RE: **Workplan to investigate the lateral extent of contamination downgradient of RS-7** as requested in the June 2, 1998 letter from Alameda County Health Care Services (ACHCS at former Desert Petroleum Station DP 793, 4035 Park Blvd. Oakland, CA 94602.

June 2, 1998

RE: Desert Petroleum site #793, 4035 Park Blvd., Oakland, CA 94602

RE: Workplan to perform Risk Base Corrective Action (RBCA) Tier two for petroleum release sites at former Desert Petroleum Station DP 793, 4035 Park Blvd. Oakland, CA 94602.

FIGURE 3-GROUNDWATER PLUME SEWER AND FREE PRODUCT INVESTIGATION FOR DP793, 4035 PARK BLVD. OAKLAND, CALIFORNIA

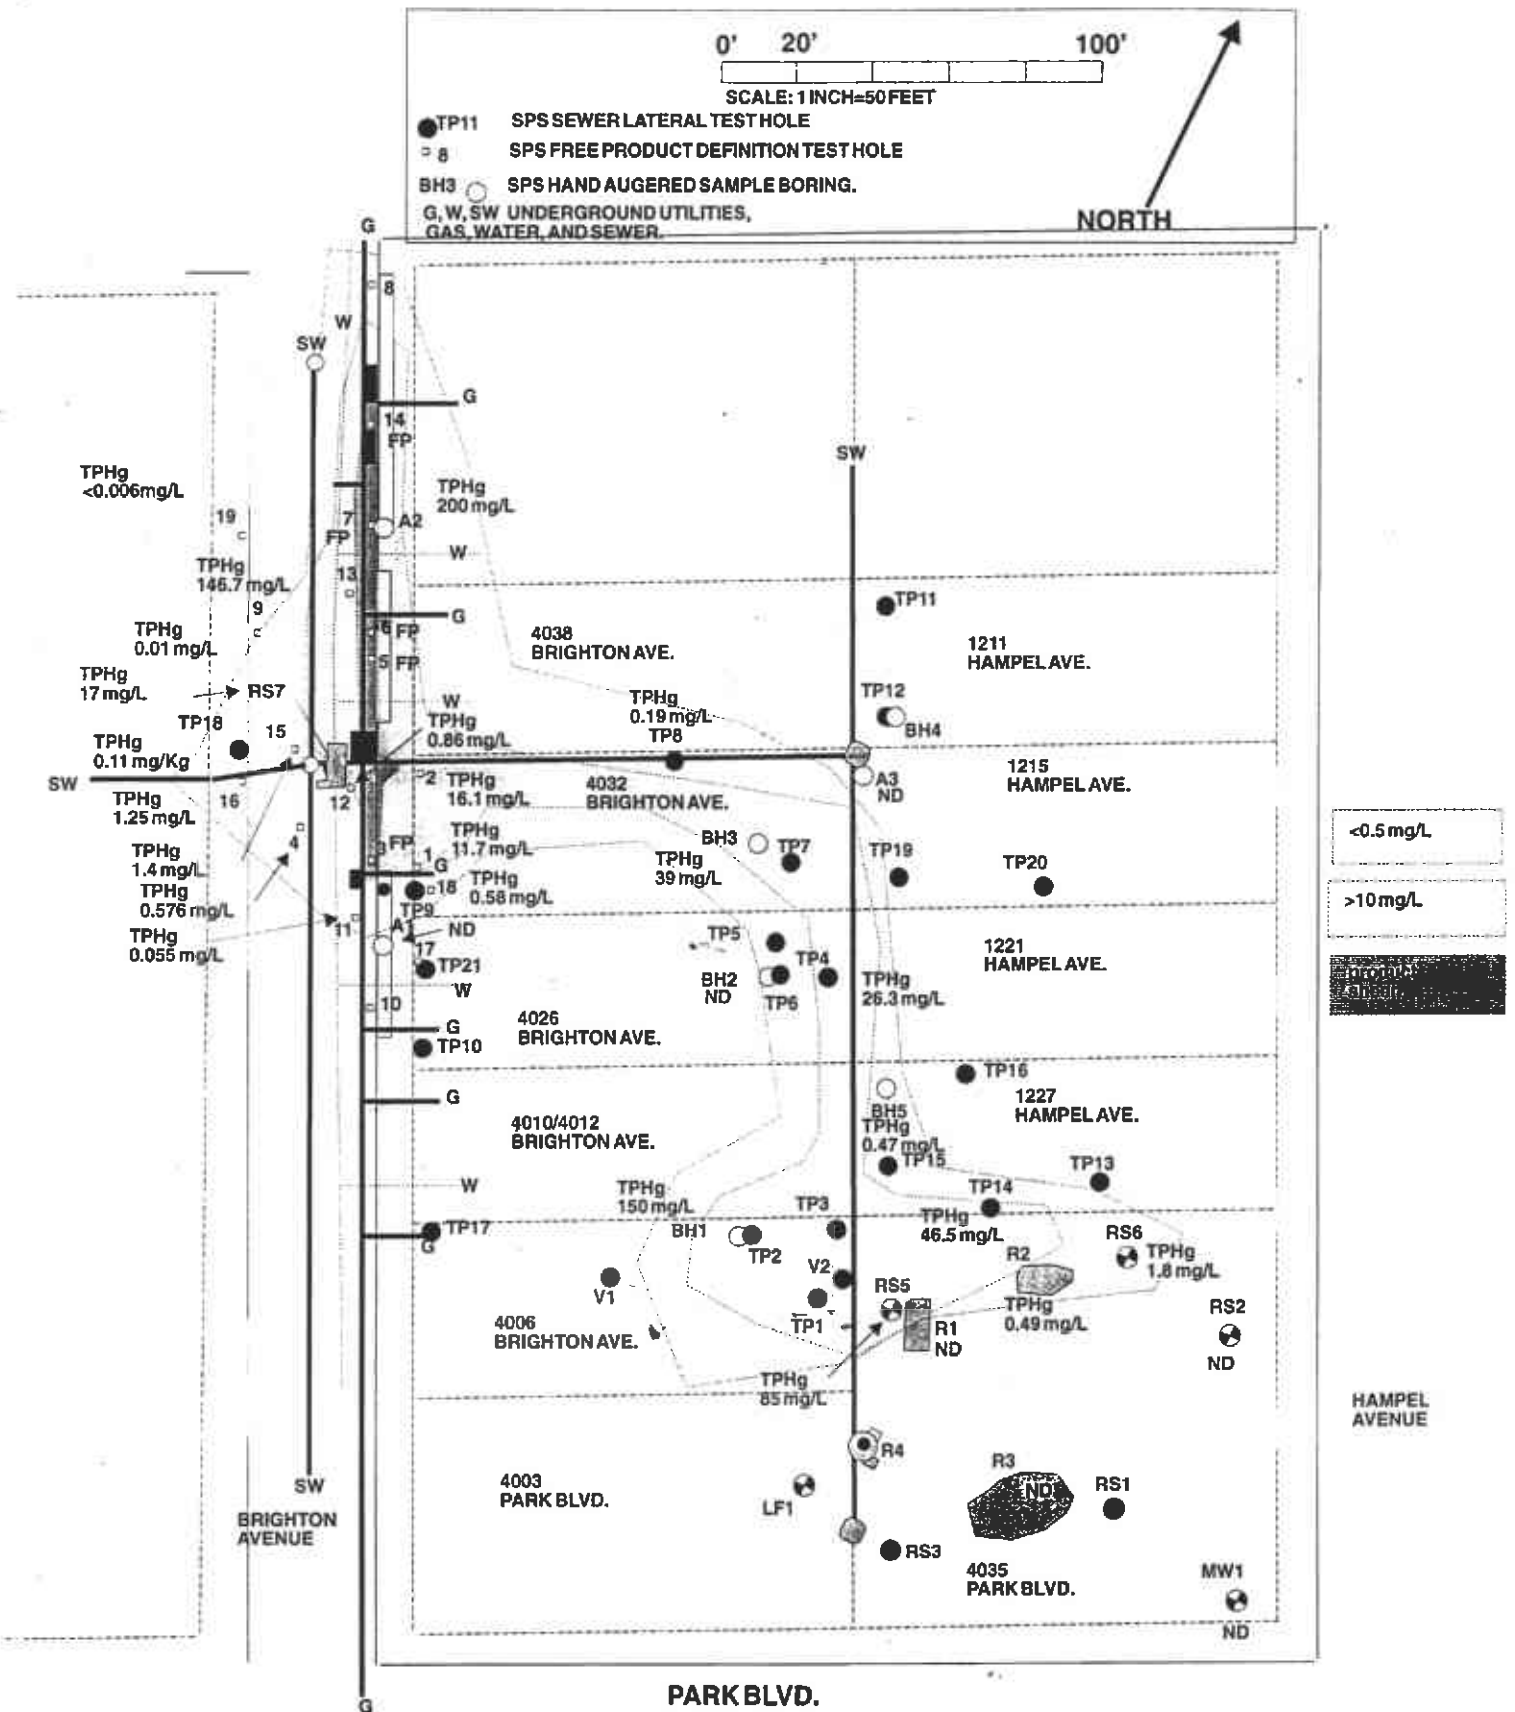
1. A complete Tier 2 assessment.
2. Investigate the lateral extent of contamination downgradient of RS-7.
3. Delineate the area that is to be used for free product removal via a receptor trench along the eastern curb/gutter area of Brighton Avenue, see Figure 3.

FIGURE 4-GROUNDWATER/SOIL PLUMES WITH UNDERGROUND UTILITIES DP 793, 4035 PARK BLVD. OAKLAND, CALIFORNIA

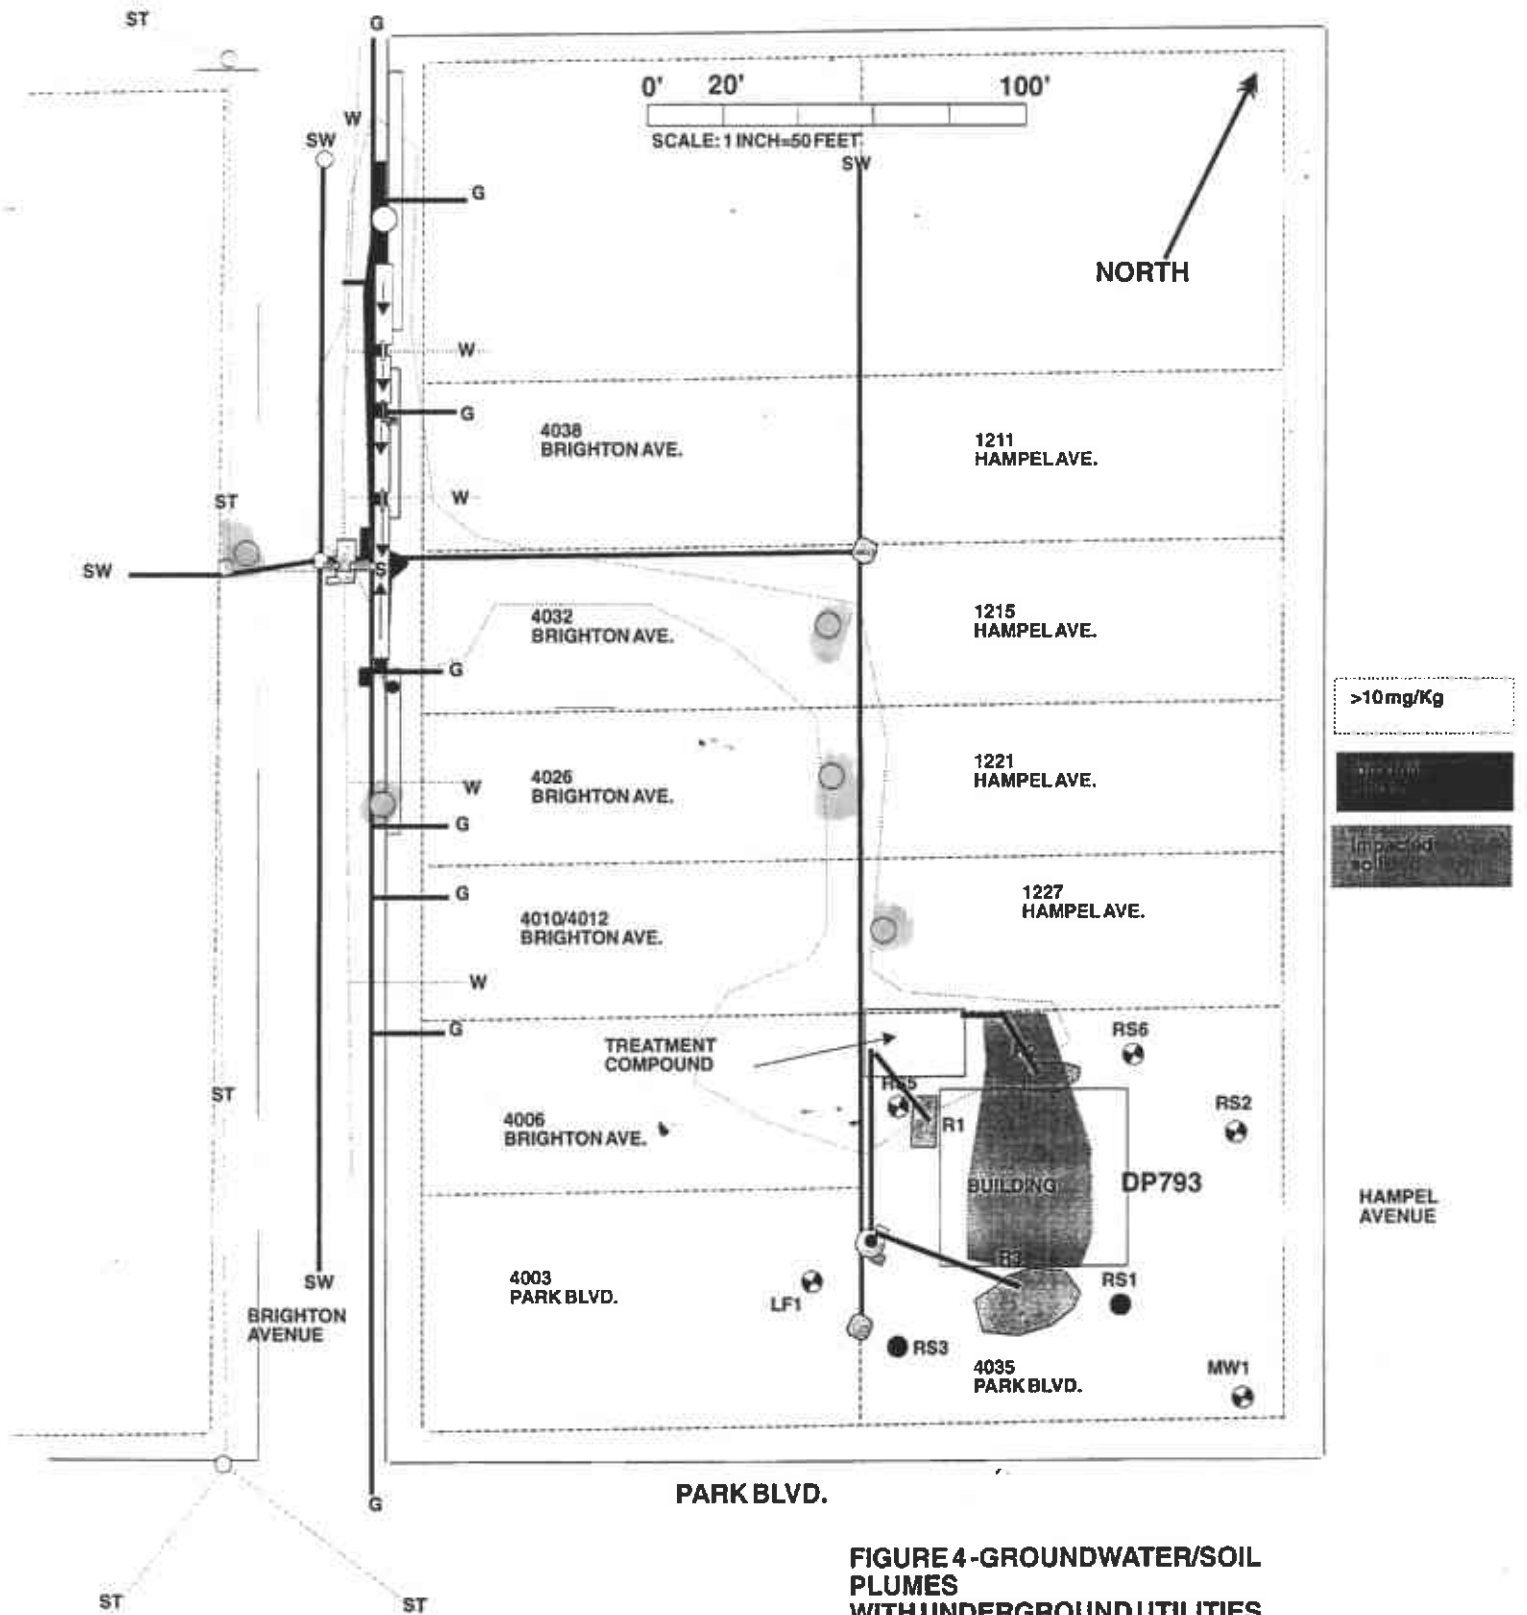
The siting of the additional 5 groundwater monitoring wells was accomplished with information generated from the two Soil Probe Surveys, which obtained soil and groundwater samples to evaluate the lateral extent of the hydrocarbon plume, see Figure 4.
